Subject: FW: WBLR phase 3 – A2300 drainage approach

Subject: WBLR phase 3 – A2300 drainage approach

Subject: RE: WBLR phase 3 – A2300 footway discharge rates

Subject: WBLR phase 3 – A2300 footway discharge rates

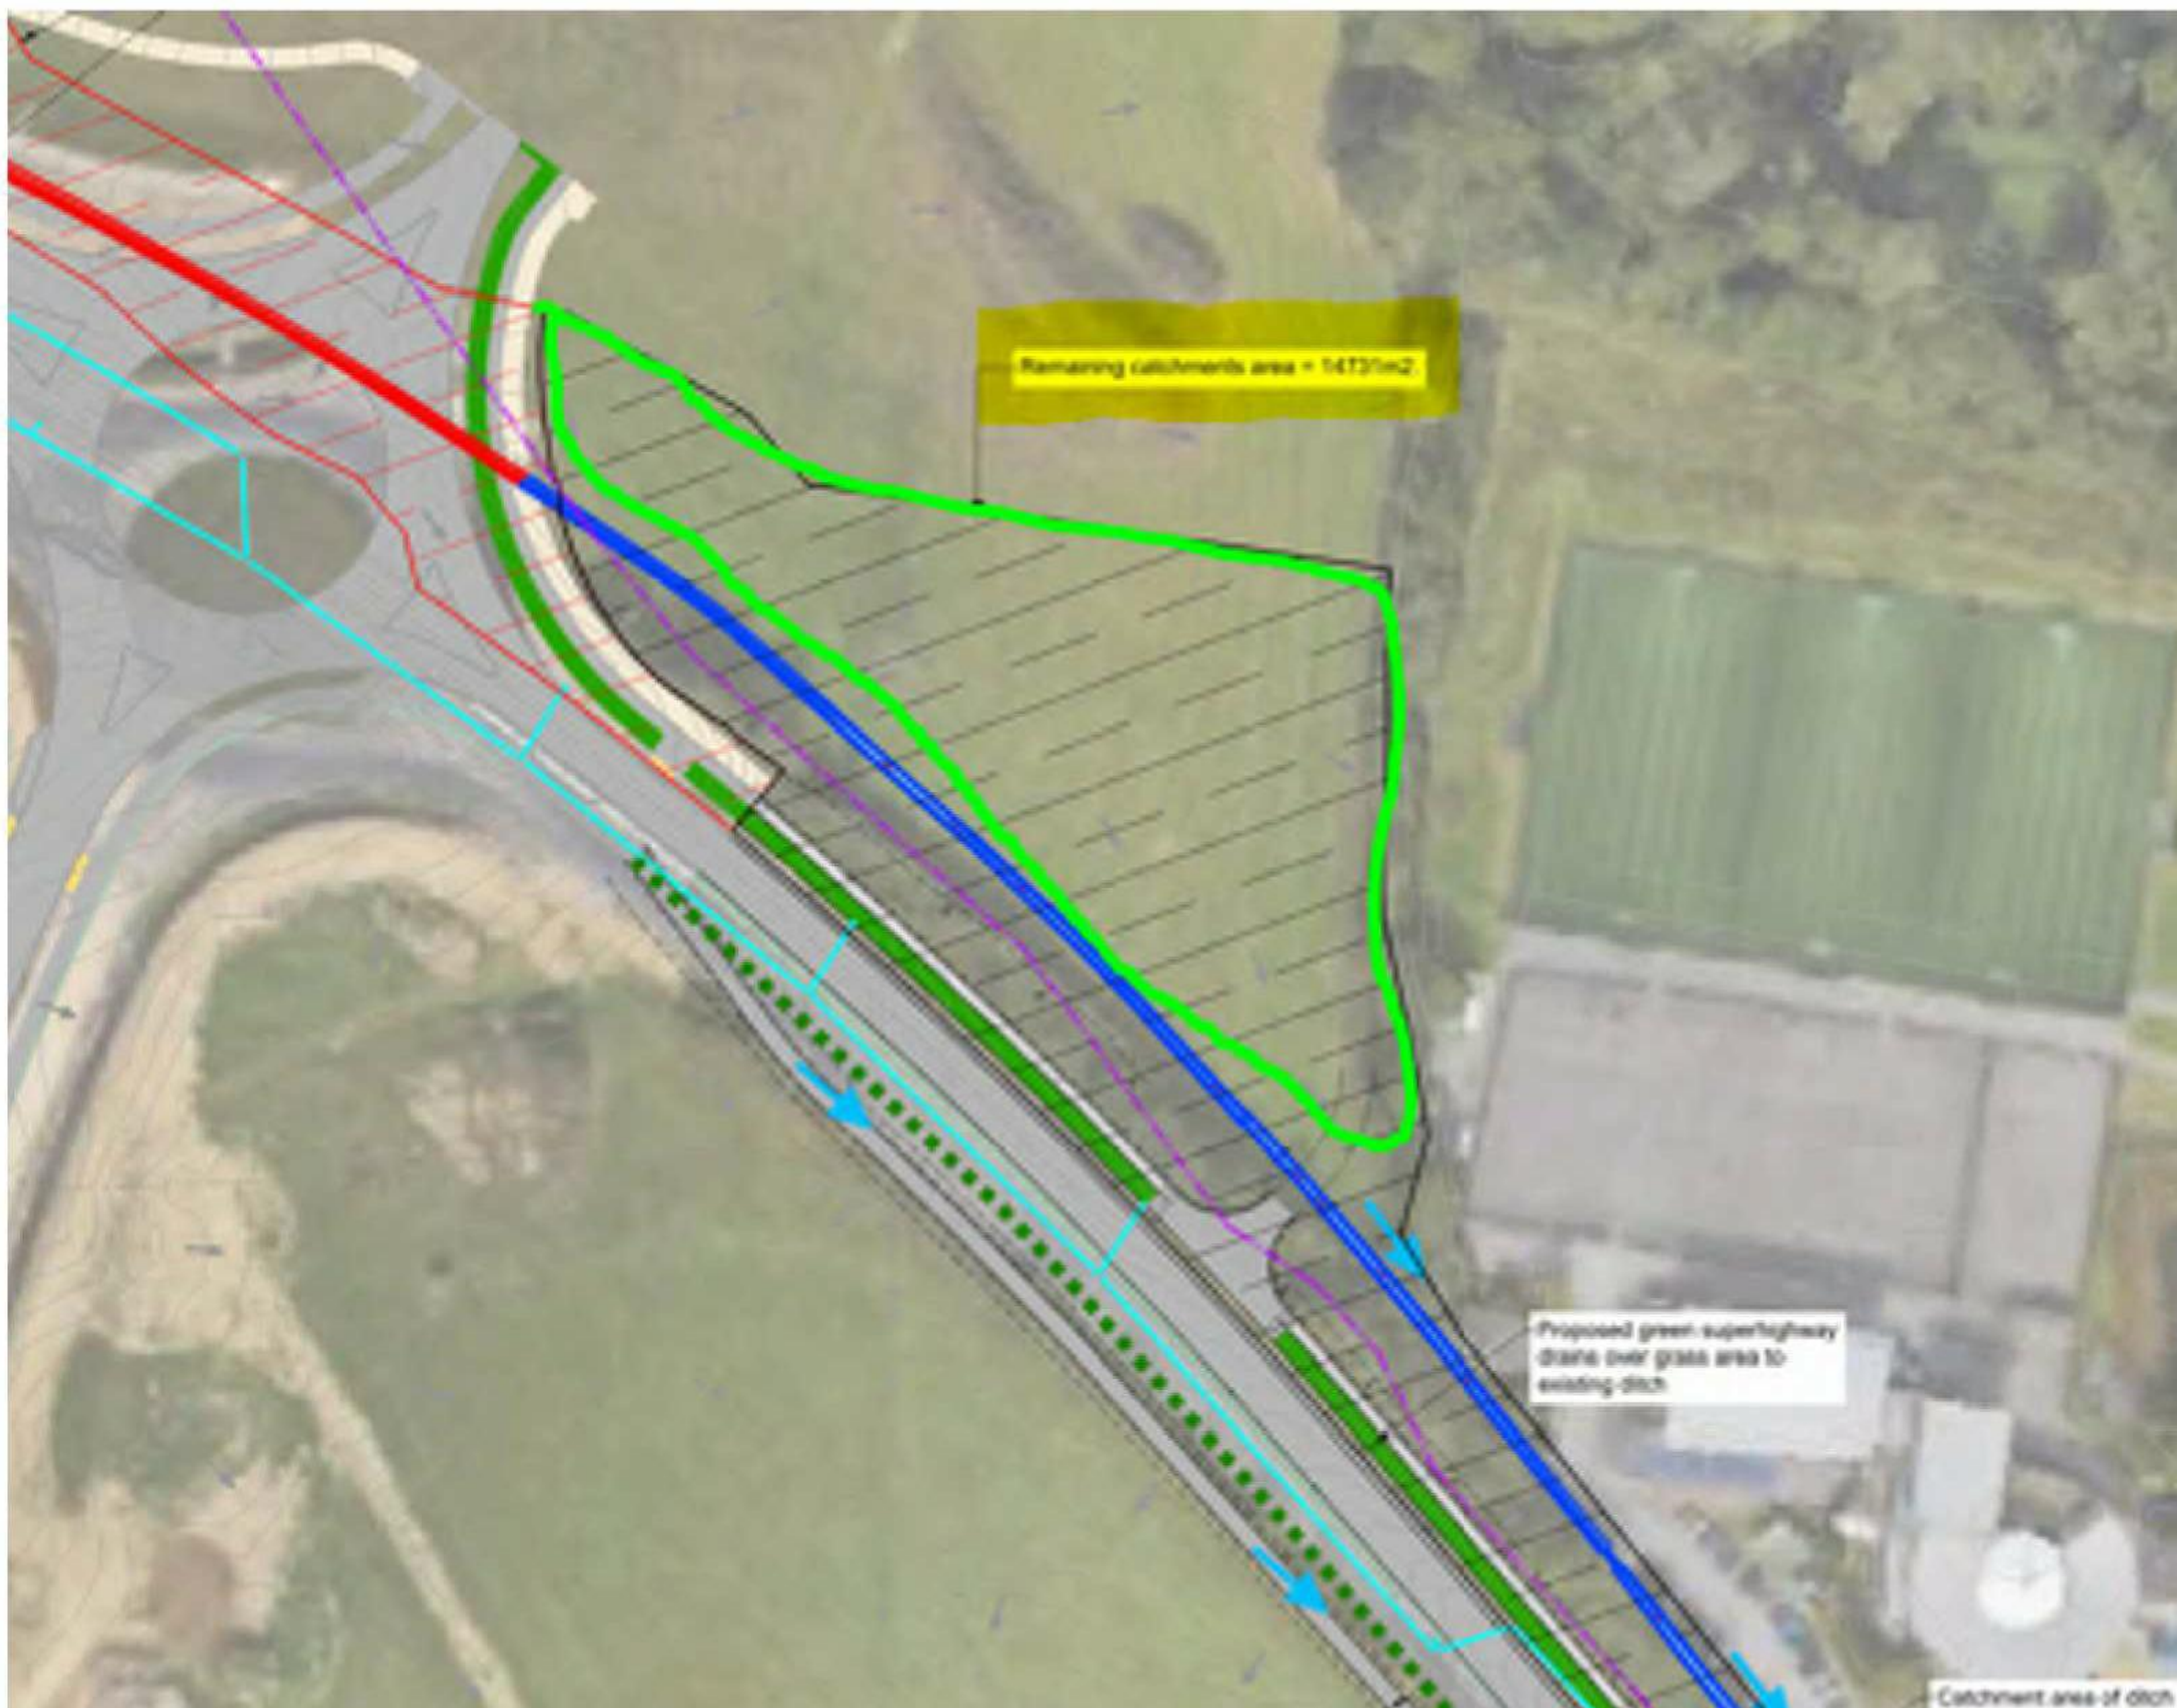
Also – another point regarding the flows into the existing ditch system that *might* have some bearing: The existing catchment includes an area of the adjacent field / development plot – approx. extent encircled in green below. When the plot is developed - a large portion of this area will then be drained to the north towards the River Adur and discharged at a controlled rate based on Qbar? We believe the plot development will not be allowed to discharge into the ditch at all - as it is a highway ditch in highway land? When this occurs – the flows in the ditch and then through the A2300 culvert will be further reduced such that they are then significantly lower than the greenfield / pre-development flows:

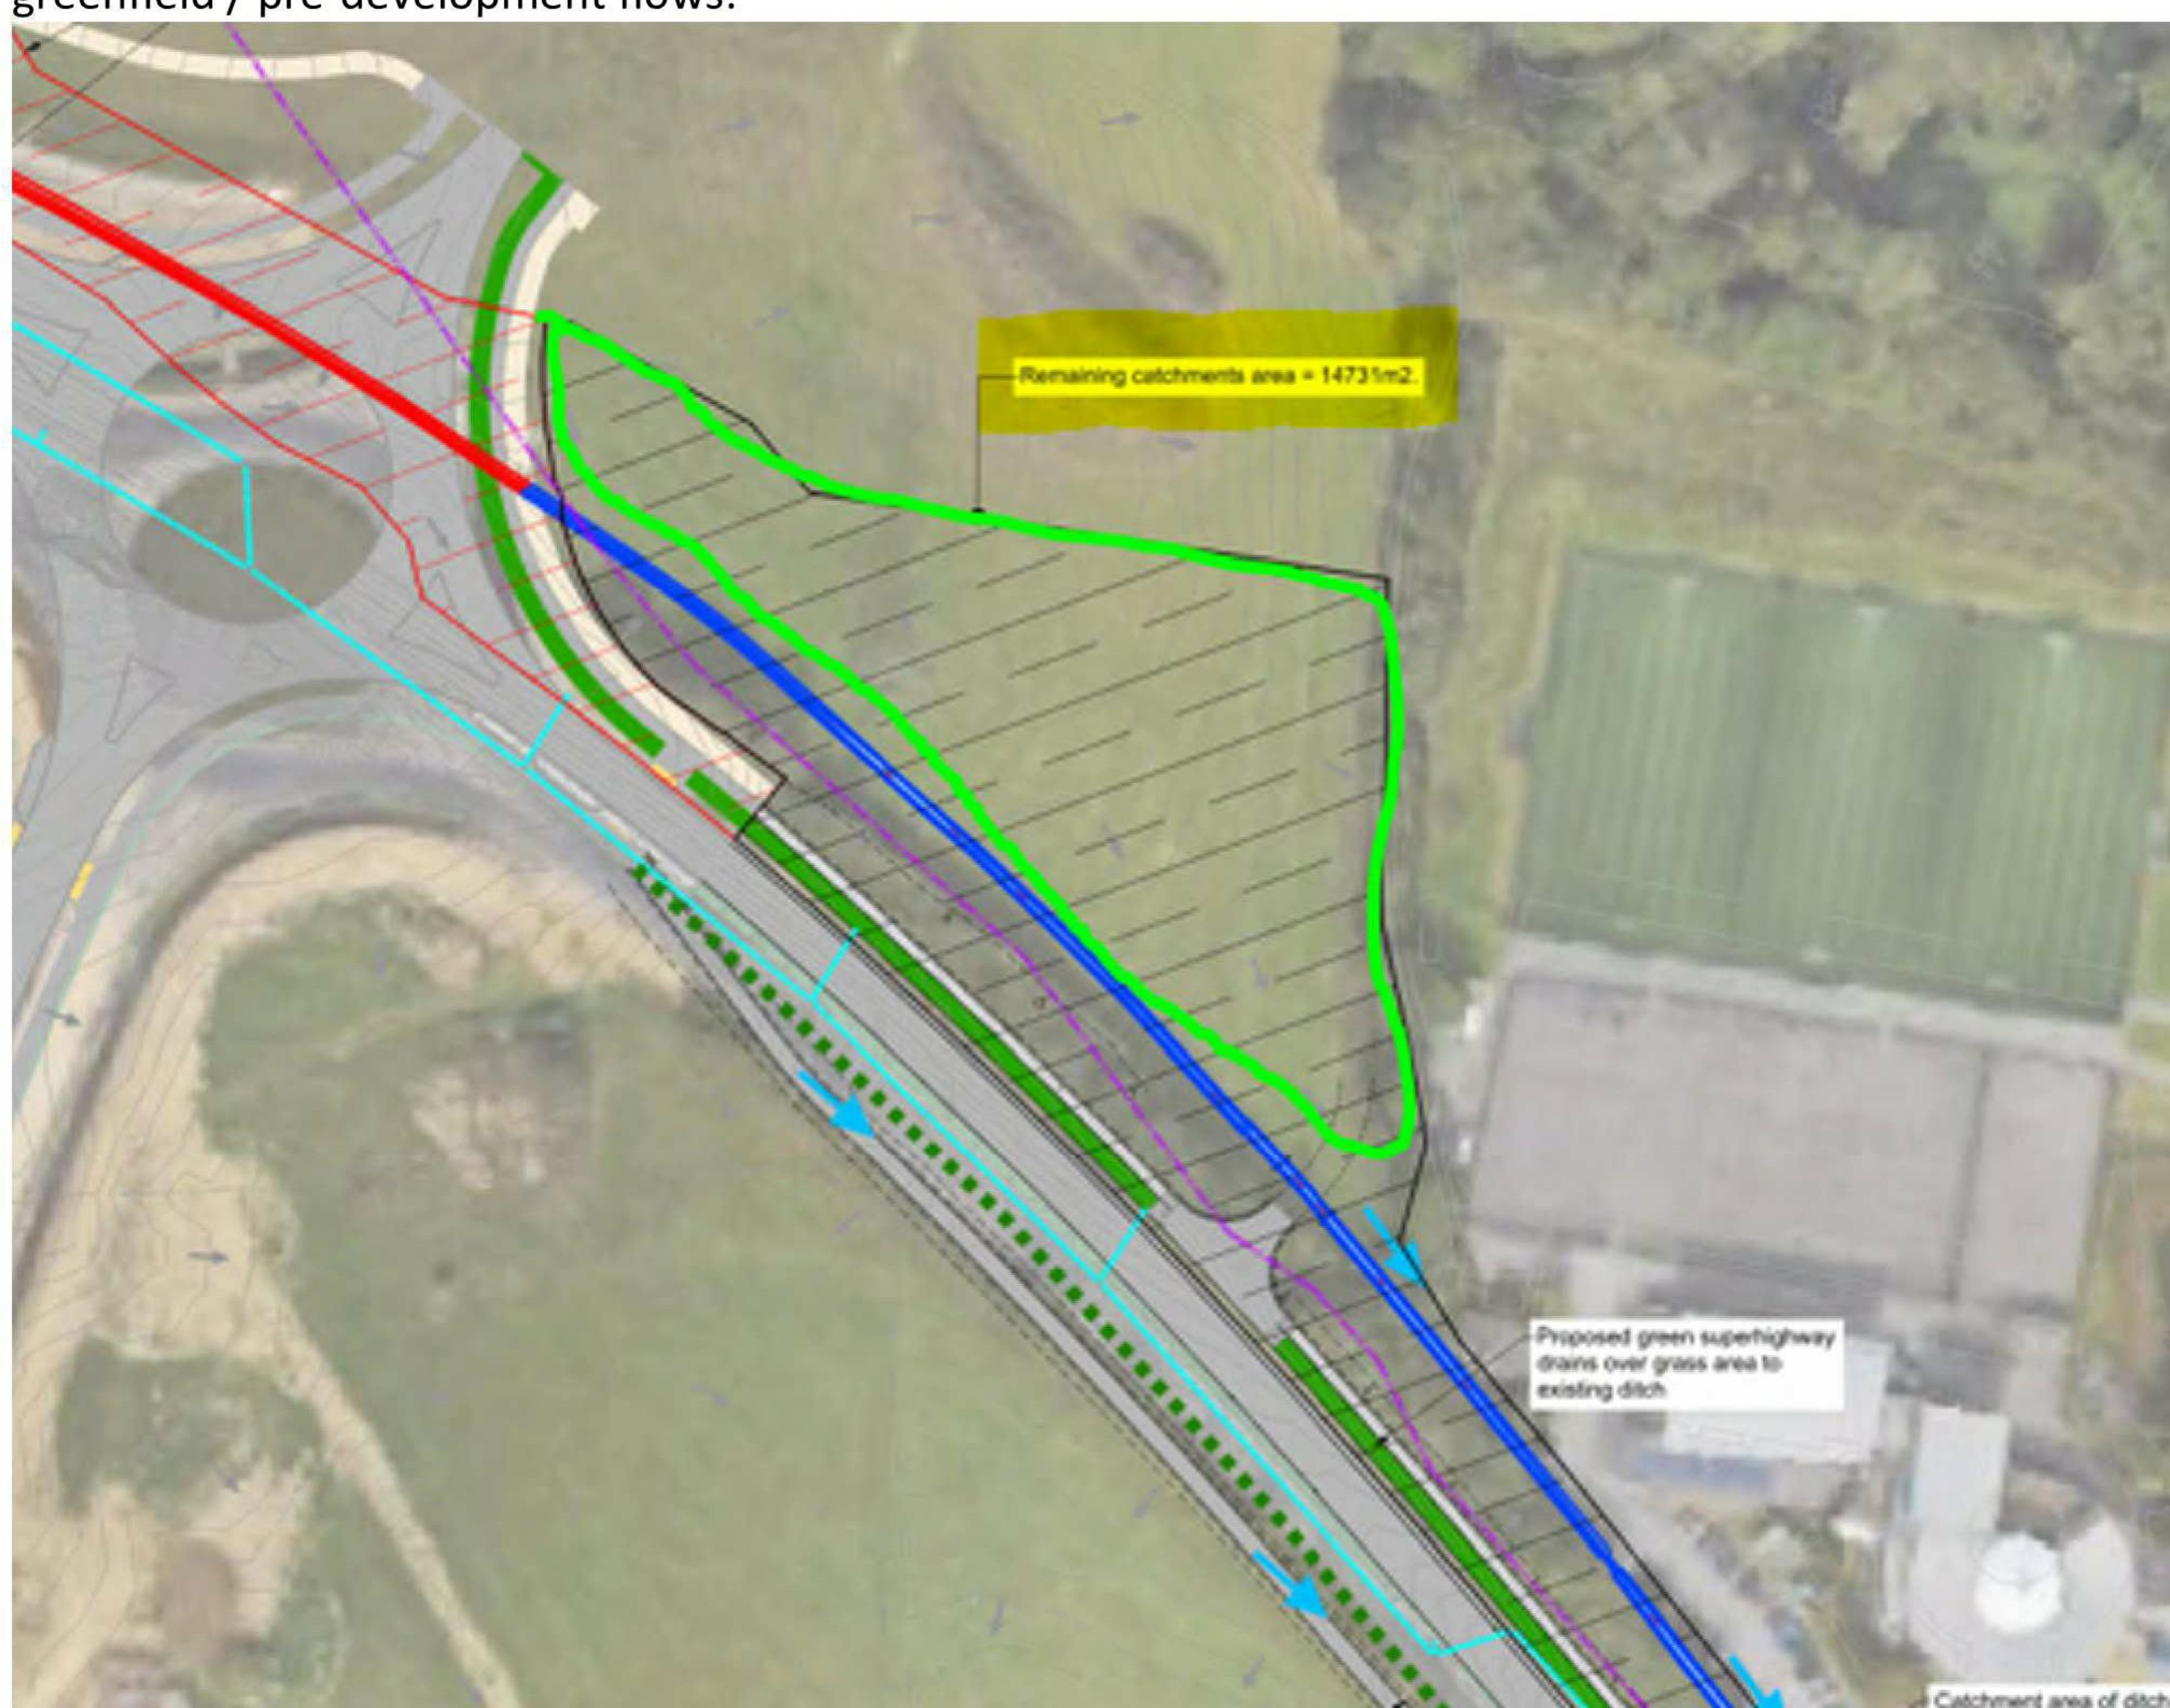
Also – another point regarding the flows into the existing ditch system that *might* have some bearing: The existing catchment includes an area of the adjacent field / development plot – approx. extent encircled in green below. When the plot is developed - a large portion of this area will then be drained to the north towards the River Adur and discharged at a controlled rate based on Qbar? We believe the plot development will not be allowed to discharge into the ditch at all - as it is a highway ditch in highway land? When this occurs – the flows in the ditch and then through the A2300 culvert will be further reduced such that they are then significantly lower than the greenfield / pre-development flows:
